# Evaluation of Weakly Informed Priors for FLEX Data

May 2020

**Prepared for the  
Division of Risk Analysis  
Office of Nuclear Regulatory Research  
U.S. Nuclear Regulatory Commission  
NRC Agreement Number 31310019N0006  
Task Order Number 31310019F0022**

On behalf of the U.S. Nuclear Regulatory Commission, Idaho National Laboratory (INL) reviewed the development and use of weakly informed prior (WIP) probability distributions to obtain industry-wide failure probability and rate distributions for portable FLEX equipment, as documented in the Pressurized Water Reactor Owner's Group (PWROG) draft report, *FLEX Equipment Data Collection and Analysis* (PWROG-18043-P Revision 0) by M.M. Degonish. The review includes a description of the methods used by the PWROG analysts. It also includes an implementation of those methods for comparison purposes, as well as an implementation of two constrained noninformative (CN) distributions for further WIP comparisons.

Figure 1. Posterior distribution 5<sup>th</sup> percentiles, mean values, and 95<sup>th</sup> percentiles for the probability of failure to start for components with WIP distributions.

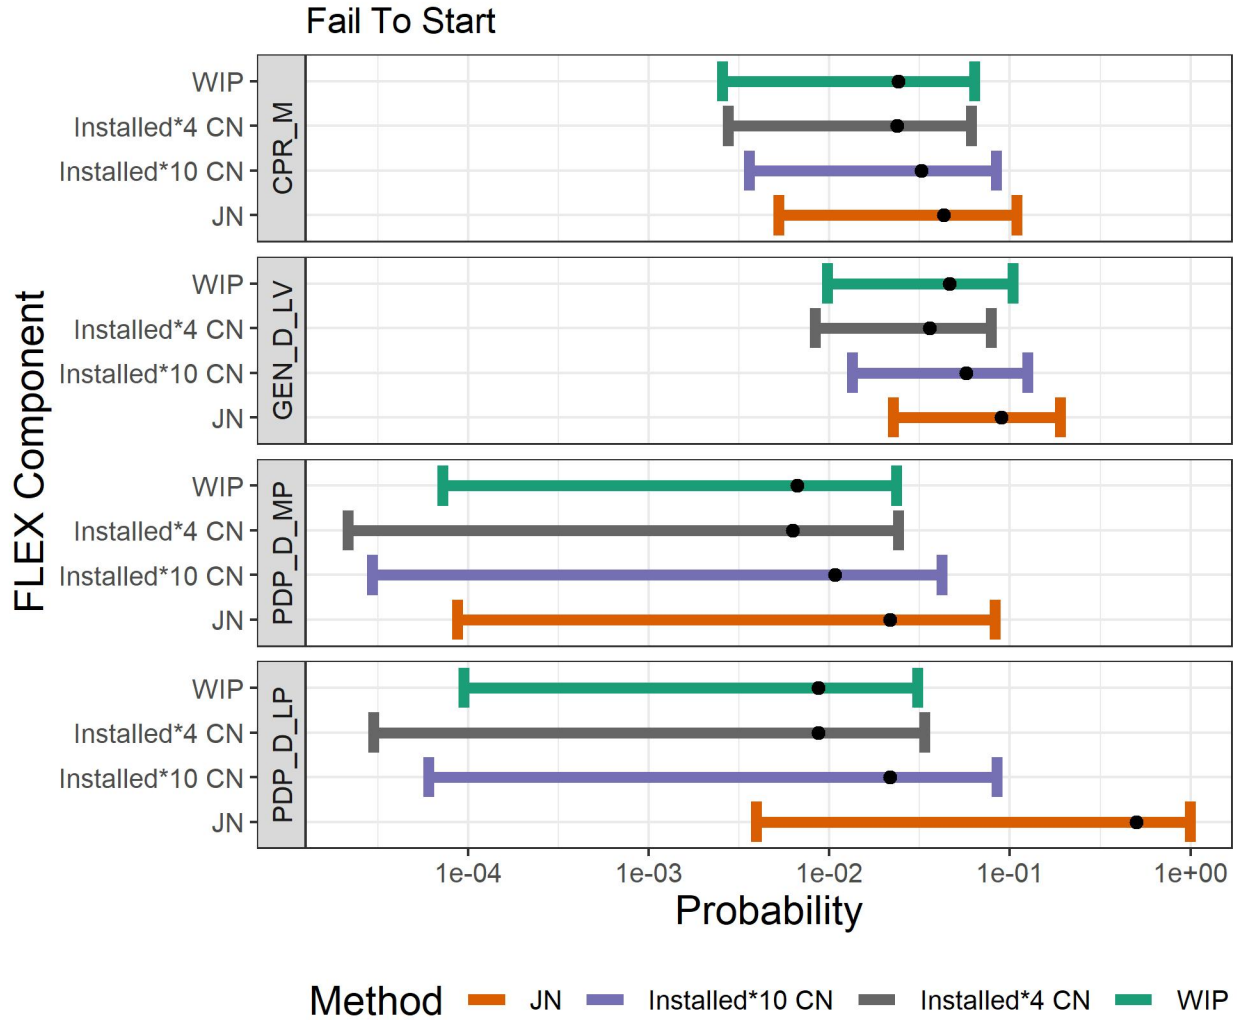
In Figure 1, component labels are in the gray boxes on the left side of the plot. The first three letters describe the component type, as follows:

The fourth character describes the driver: D (diesel) or M (motor). The third label, if given, describes the operating conditions. Here, LV is low voltage, MP is medium pressure/medium flow rate, and LP is low pressure/high flow rate. Also, in Figure 1, the WIP means and percentiles are labeled “WIP,” the two CN distribution outputs are labeled “Installed\*4\_CN” and “Installed\*10\_CN,” and the Jeffreys output is labeled “JN”.

In each figure, the components are sorted so the ones at the top of the figures are those with the most demands or run hours, and the components at the bottom are those with the least operational data.

Both figures show similar observations:

- The means and bounds generally have a smaller spread for the components at the top of the figures, and a larger spread for those at the bottom, reflecting the impact of more operational experience. The narrowest bands, however, are for the components that had failures. In Figure 1, the top component had one failure and the second had two. The other components had no failures. In Figure 2, no components had failures, except for the one in the second band (PDP\_M\_MP) that had one failure.

- In virtually every case, the JN method has the highest mean and the highest 95<sup>th</sup> percentile. Among the methods considered, it is the only one not influenced by the industry installed equipment mean values.

- The two CN distributions have identical spreads for their bounds because they have the same alpha parameter for FTR rates, as well as similar alpha parameters for FTS probabilities. As expected, the Installed\*10\_CN bounds and mean are to the right (higher probabilities and rates) than the Installed\*4\_CN values.

- The WIP distribution posterior mean values are close to the Installed\*4\_CN posterior mean values. Both distributions have the same prior mean.
- In every case in Figure 2 (FTR distributions), the WIP posterior distributions appear narrower than the other distributions. This is not so apparent in Figure 1 (FTS), which reflects the changes that occurred when the algorithm for finding beta distributions with specified means and variances was corrected. One effect of the change was that the prior alpha parameters became much lower. The change widens the prior distribution, thus somewhat widening the posterior FTS distributions, as well.

Figure 2. Posterior distribution 5th percentiles, mean values, and 95th percentiles for the rate of failure to run for components with WIP distributions.

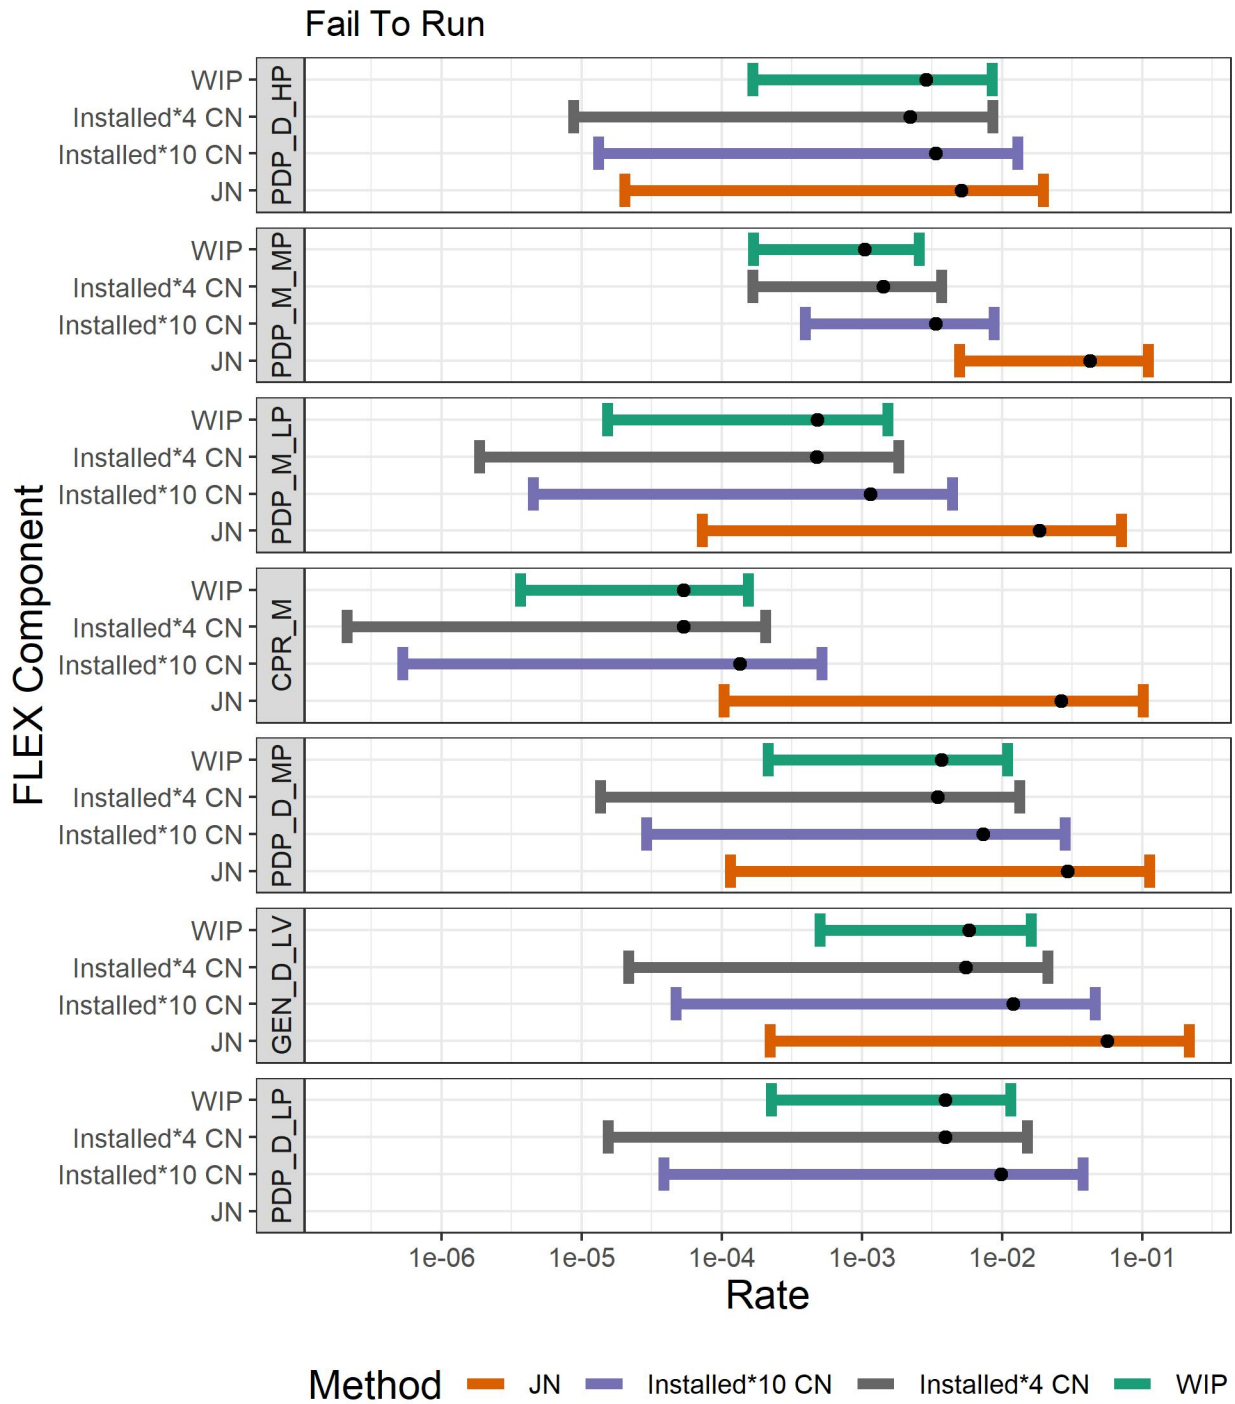
Figure 2 is similar to Figure 1, except that it shows results for the seven components with WIP distributions for FTR. The WIP distributions are from the PWROG report. The component types and drivers are the same as those for the FTS WIP plot. An additional operating condition code, “HP,” stands for high pressure/low flow rate for pumps. Acronyms for the distribution methods are the same as in Figure 1.

Two features in Figure 2 deserve further explanation. First, there is no JN plot for the component at the bottom of the figure (PDP\_D\_LP). The diesel-driven positive displacement pumps with low

pressure/high flow rates had absolutely no data (no operating hours, no demands, no failures), though they are listed in the PWROG study. For the JN method for gamma distributions, the data mean is  $(f+0.5)/T$ , so run time must be greater than 0 to evaluate the posterior mean.

The second anomaly in Figure 2 is the lower WIP and CN distribution bands for motor-driven compressors (the middle set of bands in this plot). The values are low because the FTR industry value for installed compressors is an order of magnitude lower than the other values used in the FLEX component study.

Figure C-1. Posterior WIP and JN mean values for the probability of a component's failure to start as a function of the number of demands.

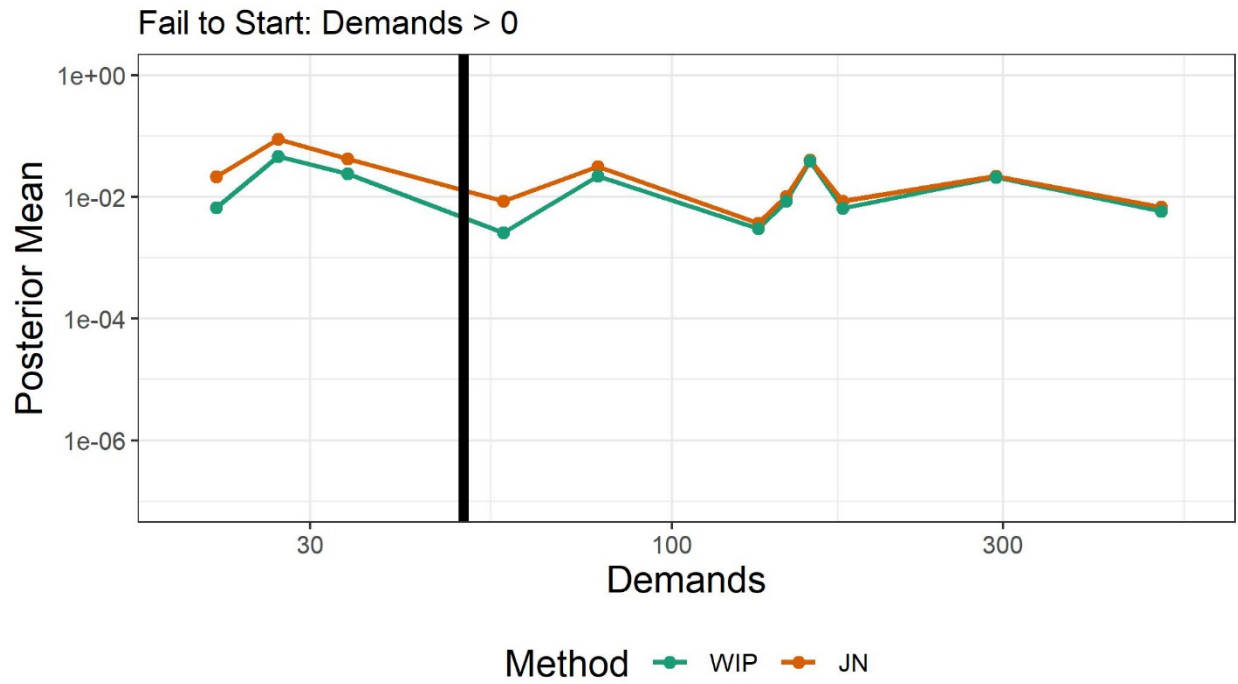
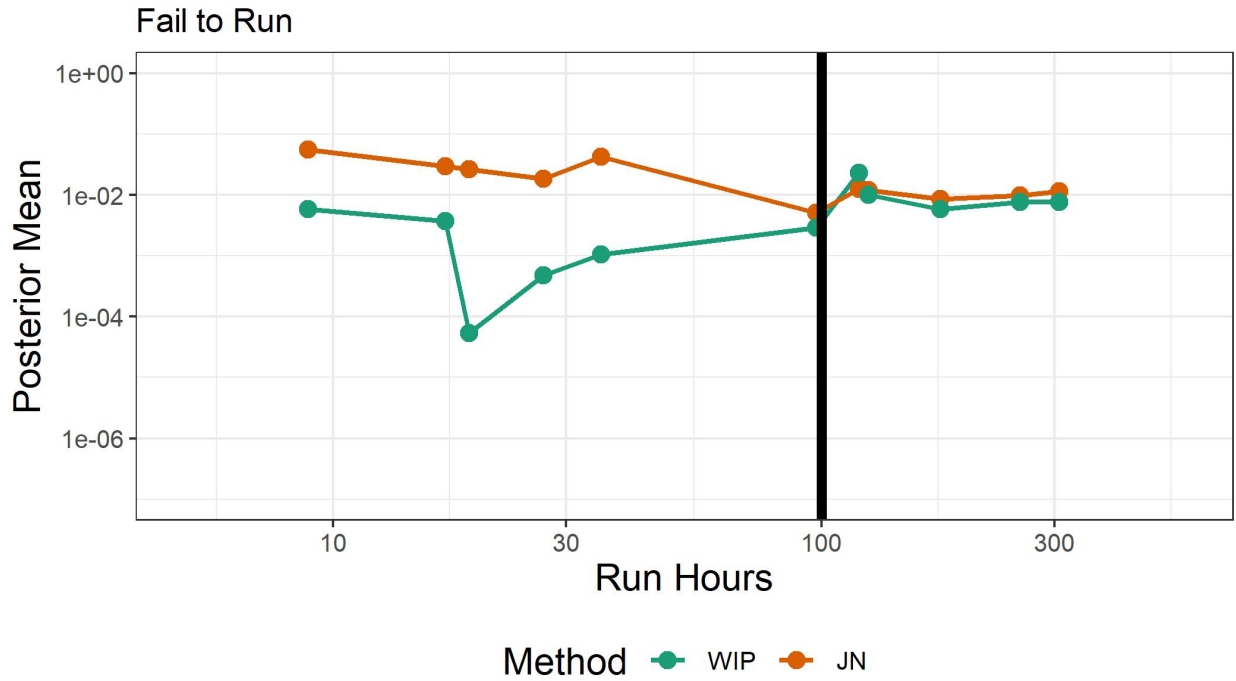
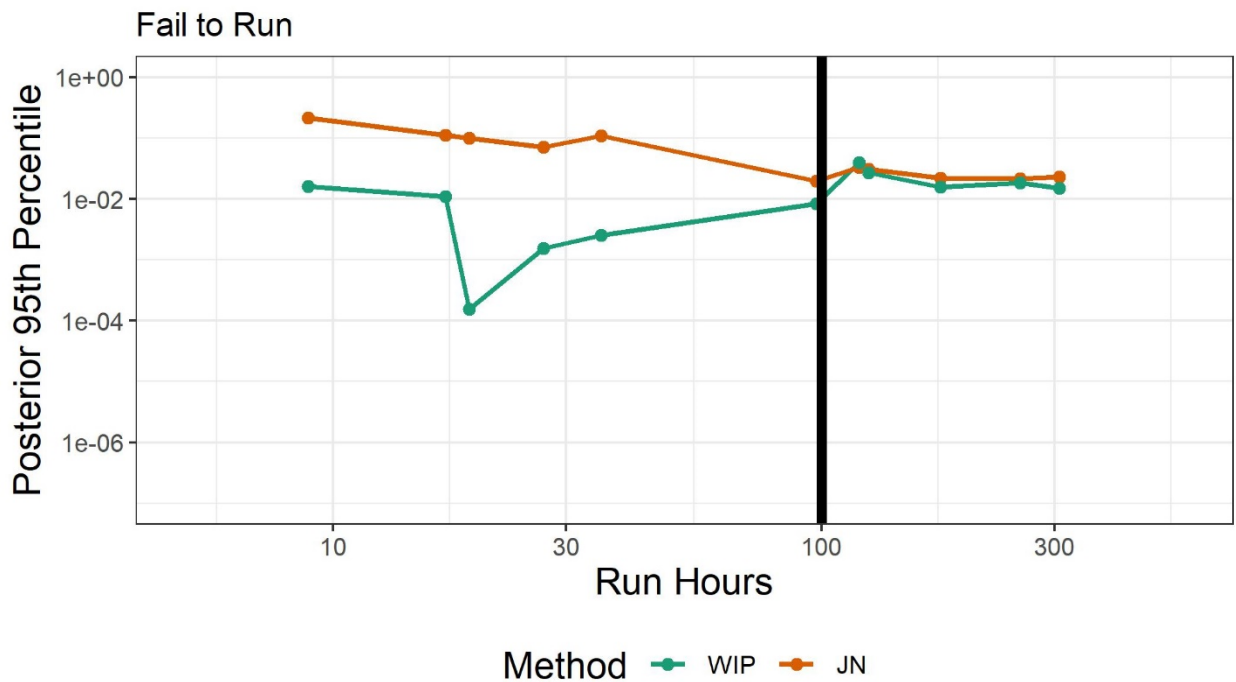
Figures C-1 and C-2 show FTS posterior distribution information as a function of the number of demands, while Figures C-3 and C-4 show the same information for FTR as a function of run hours. The first figure in each pair contains WIP and JN means, while the second contains WIP and JN 95<sup>th</sup> percentiles. In each of the plots, the PWROG employed the WIP method only for situations to the left side of the reference line and the JN method only for those to the right side of the reference line. The JN curve on the left and the WIP curve on the right show the effects of moving the cutoff values.

The JN distribution uses only the FLEX data, whereas the WIP distributions start with data for installed components that have been used for years in the NPP industry. The mean values for the industry data are thus typically lower than those that come from the FLEX data (even though those mean values are increased by a factor of 4). The dip in Figures C-3 and C-4 in the PWROG (WIP) data are caused by a 1.35E-5 industry value for motor-driven air compressors. It is unsurprising that lowering the cutoff values increases the estimated mean and standard deviation. Sometimes, the difference is greater than an order of magnitude. This situation holds true for both FTS and FTR.

The 95<sup>th</sup> percentile plots show a similar pattern, with the JN values considerably higher than the WIP percentiles on the left. Even if the mean values were the same, the JN 95<sup>th</sup> percentile would exceed the WIP percentile any time the posterior JN  $\alpha$  was less than the posterior WIP  $\alpha$  parameter. Thus, decreasing the cutoff value for WIP increases the uncertainty estimates for the affected components.

Figure E-1. Portable diesel-driven centrifugal pump (high pressure, low flow rate)—FTR.

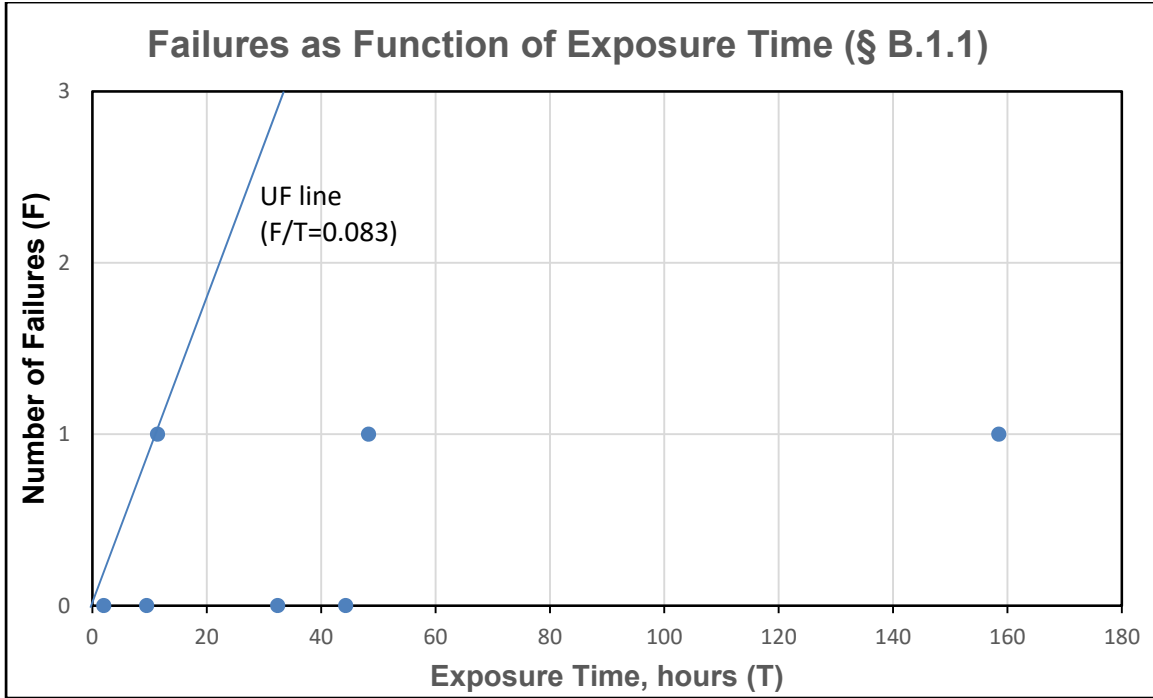
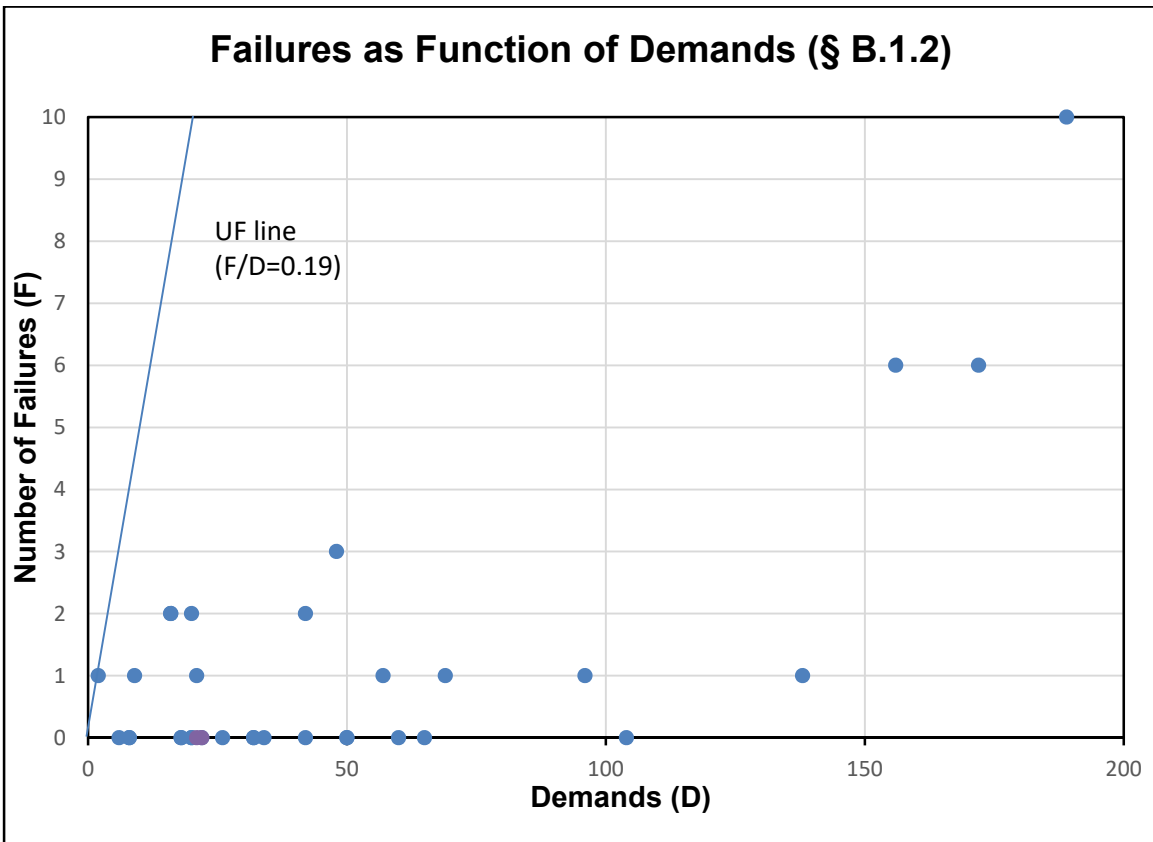
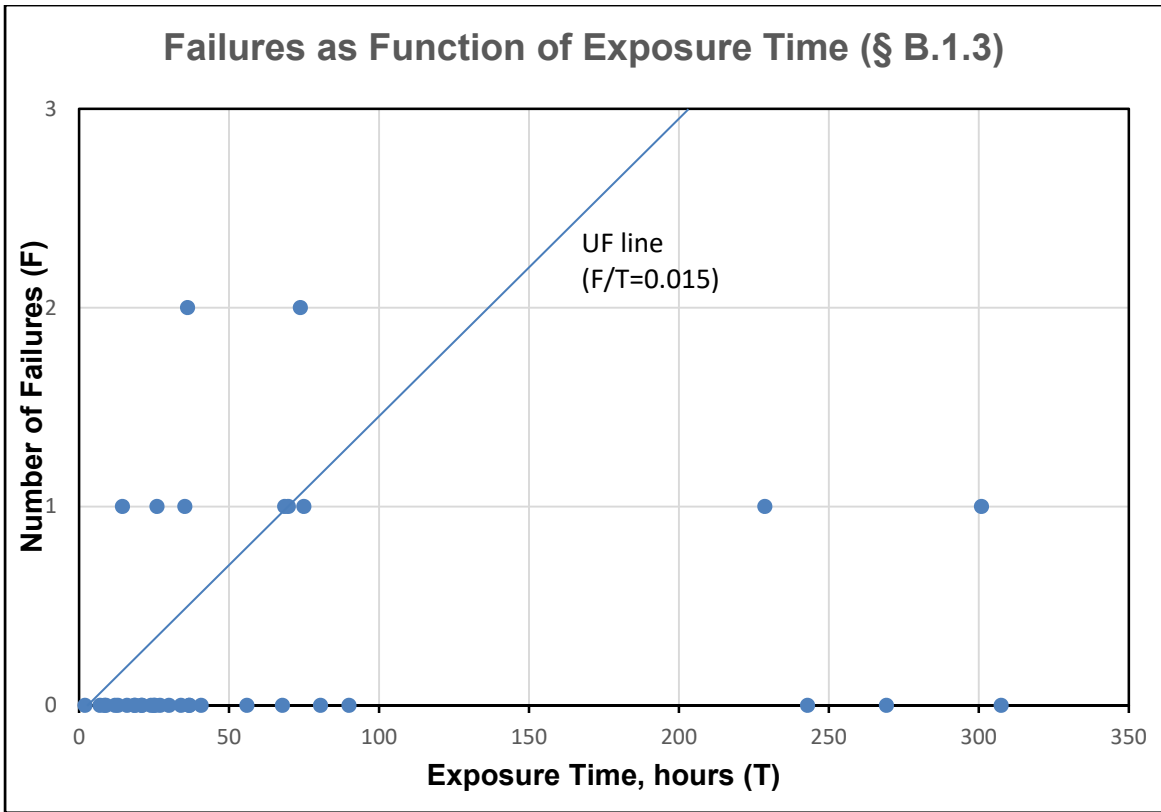
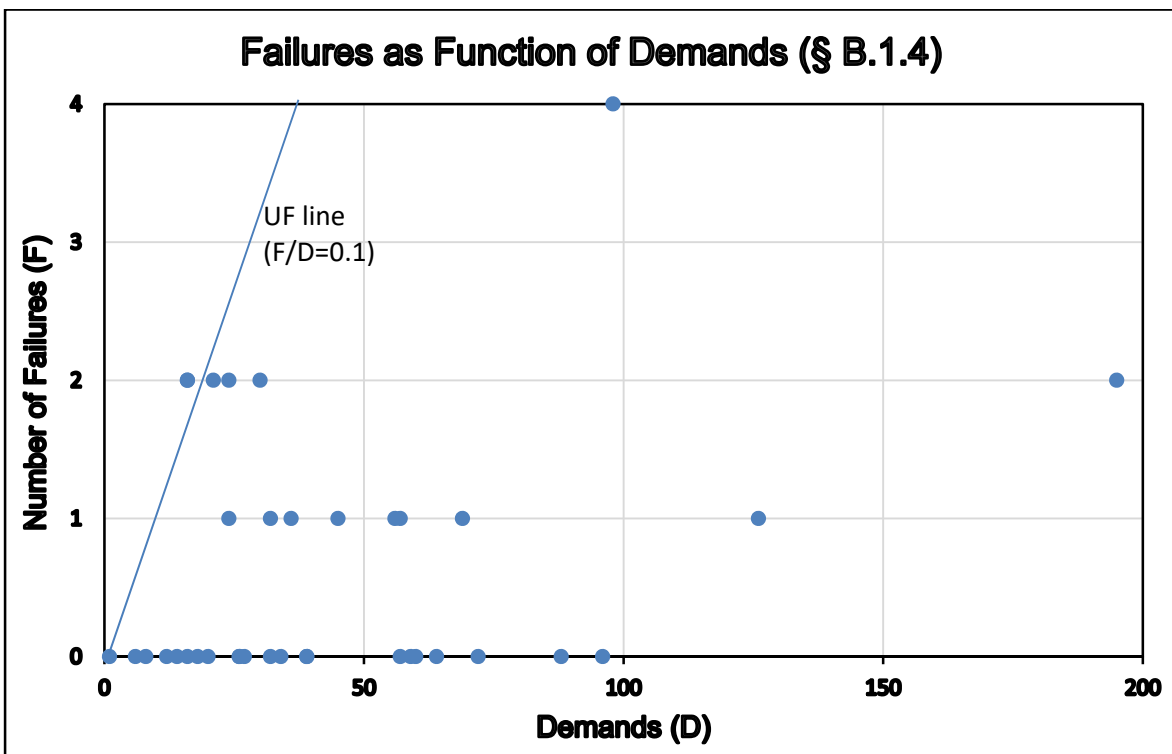
In the first two plots, only one point exceeds the UF, and it has only one failure. The demands or exposure time are low. The third plot has five points to the left of the UF. The last has just one observed point but it is actually two sites, each with two failures and the same small number of demands.

Figures E-1 through E-4 show a different type of potential outlier. The aspect of the data that most stands out to the casual observer is the great disparity in exposure times and the numbers of demands from one facility to another. Some sites have data from as early as 2008, though guidance for implementing the FLEX program was not issued until 2012, and was modified as recently as December 2016. Inclusion of data from before the implementation of the FLEX program for these sites may be the primary cause of this disparity. Including these data makes the FLEX data unbalanced. The components at those sites have a much bigger influence on the outcome than do other components. If they are atypical in any way, the datasets will be biased. Excluding old data (which would apply only to the site itself, not the industry as a whole) could produce significant changes in the PWROG FLEX uncertainty distributions.
